# EAST TOWN CROSSING | COMMERCIAL LOTS 1 & 2 - TRASH ENCLOSURE

## COMMERCIAL LOTS 1 & 2 - TRASH ENCLOSURE

**City of Puyallup**  
**Building REVIEWED FOR COMPLIANCE**

**City of Puyallup**  
**Development Engineering APPROVED**

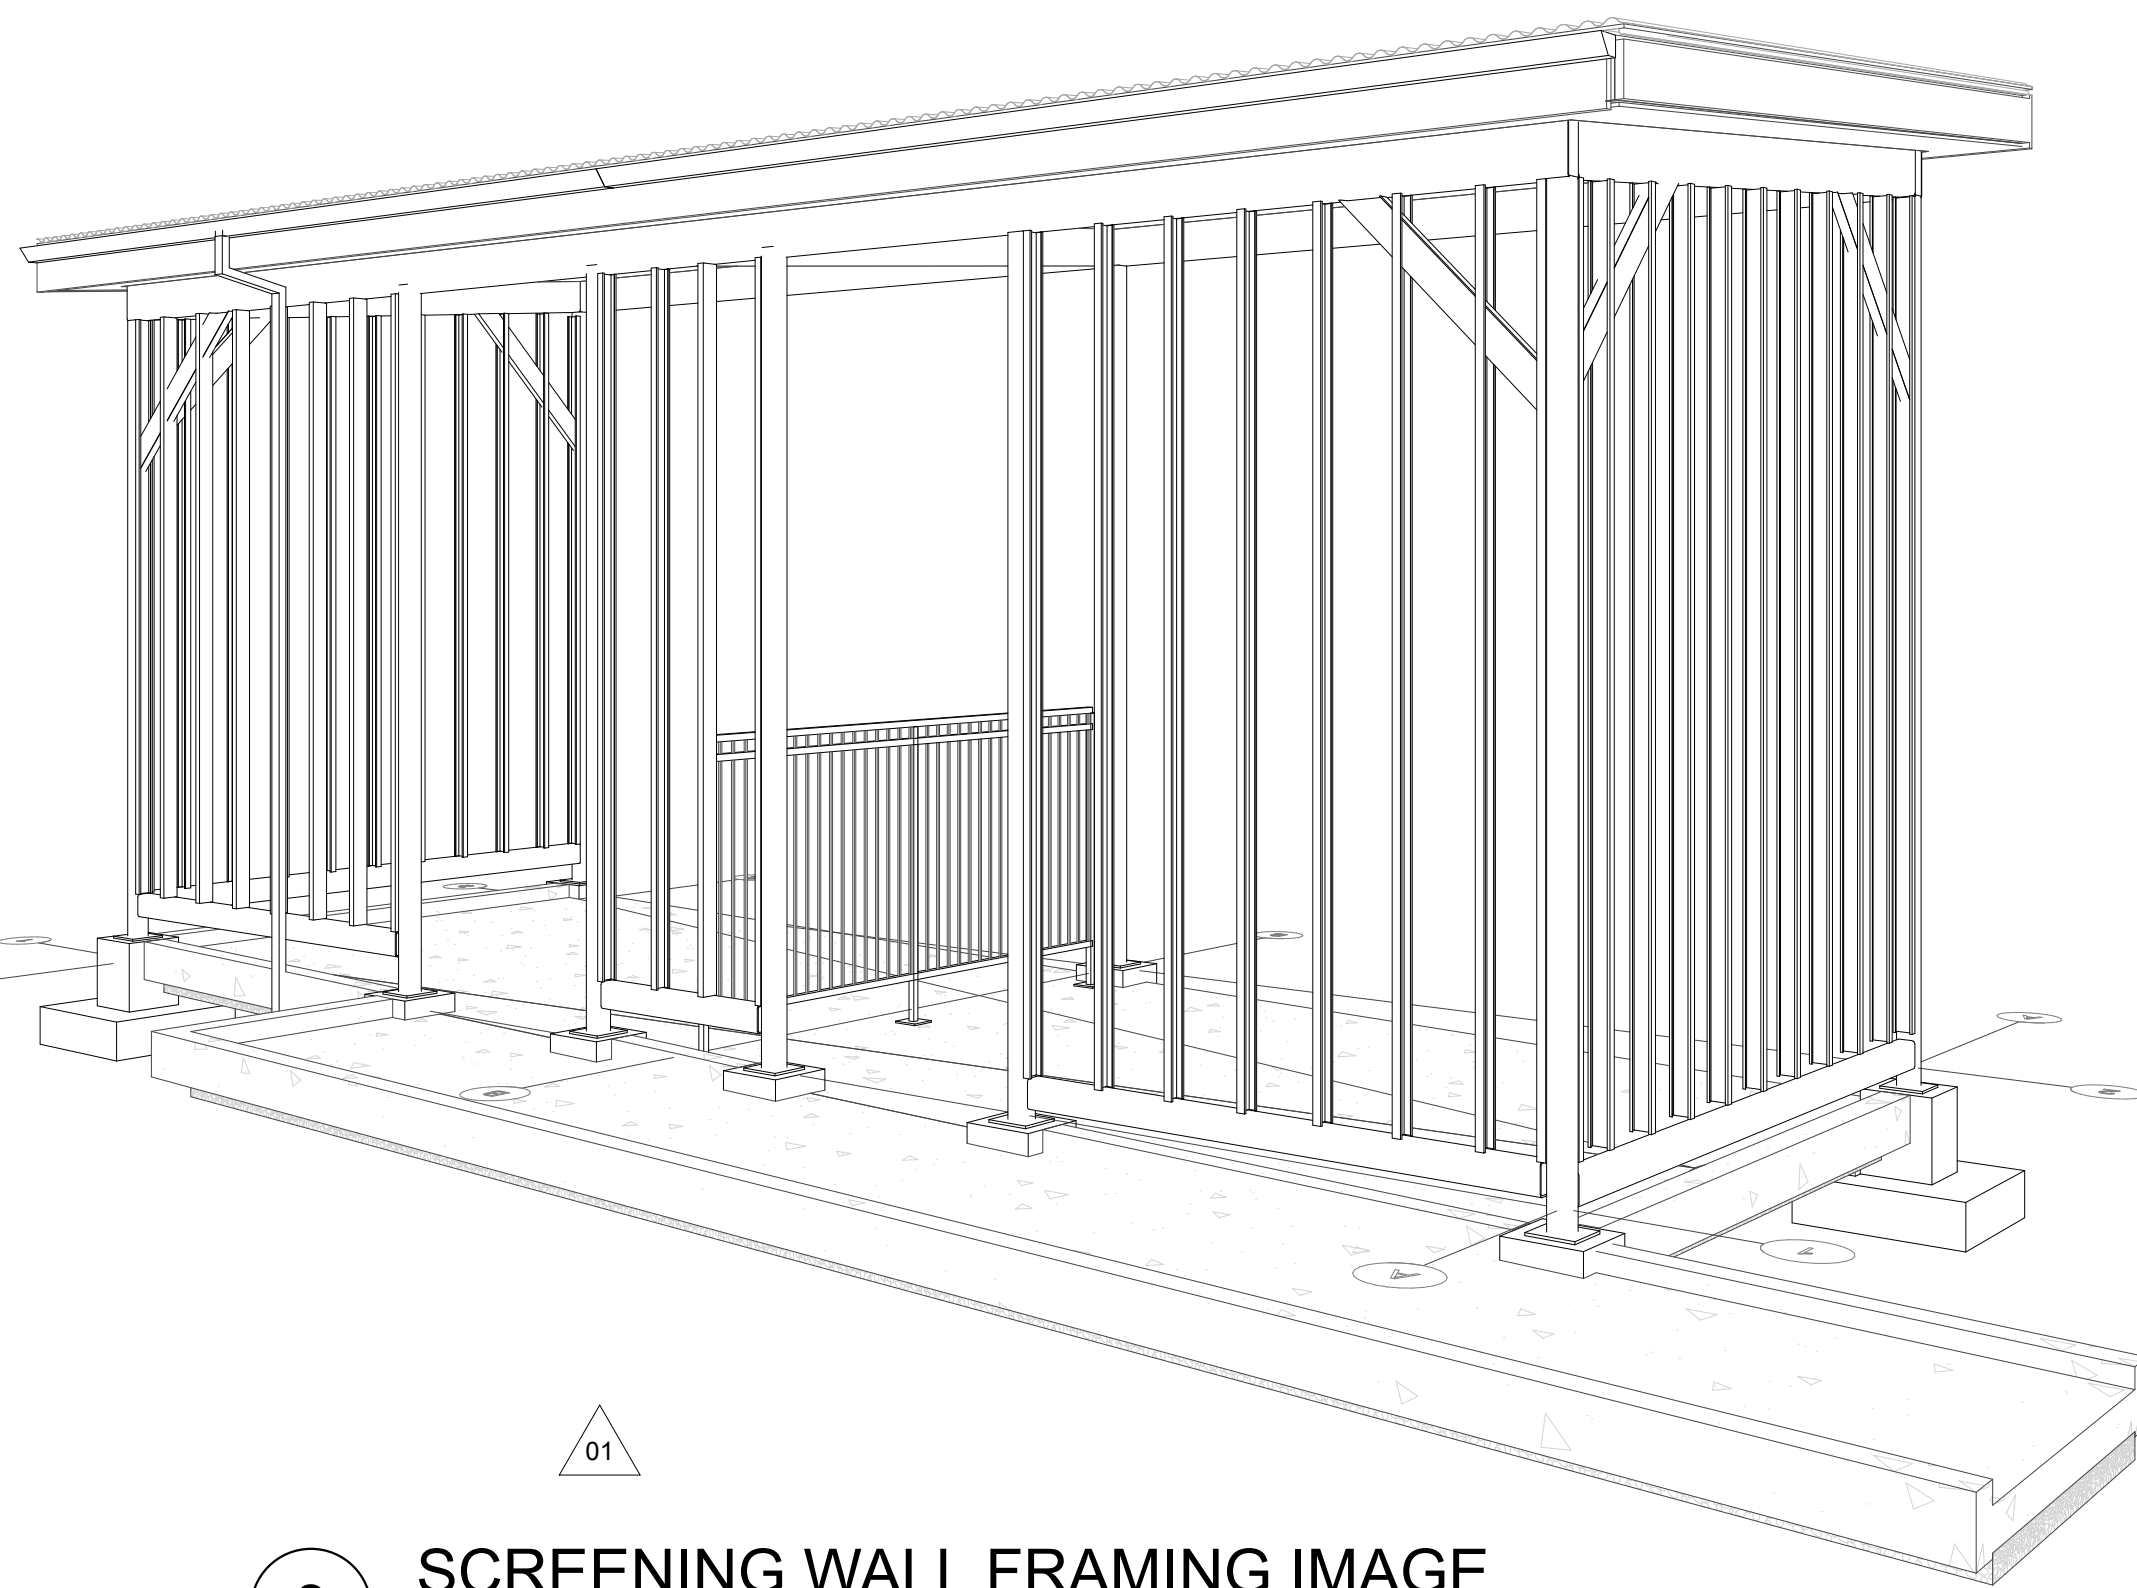
**CONTRACTOR NOTE**  
Ramp shall have a landing at each pedestrian access door entrance to provide an accessible entrance to the trash enclosure.  
Landing at access entrances shall comply with 1012.6 of the 2021 Washington State Building Code.
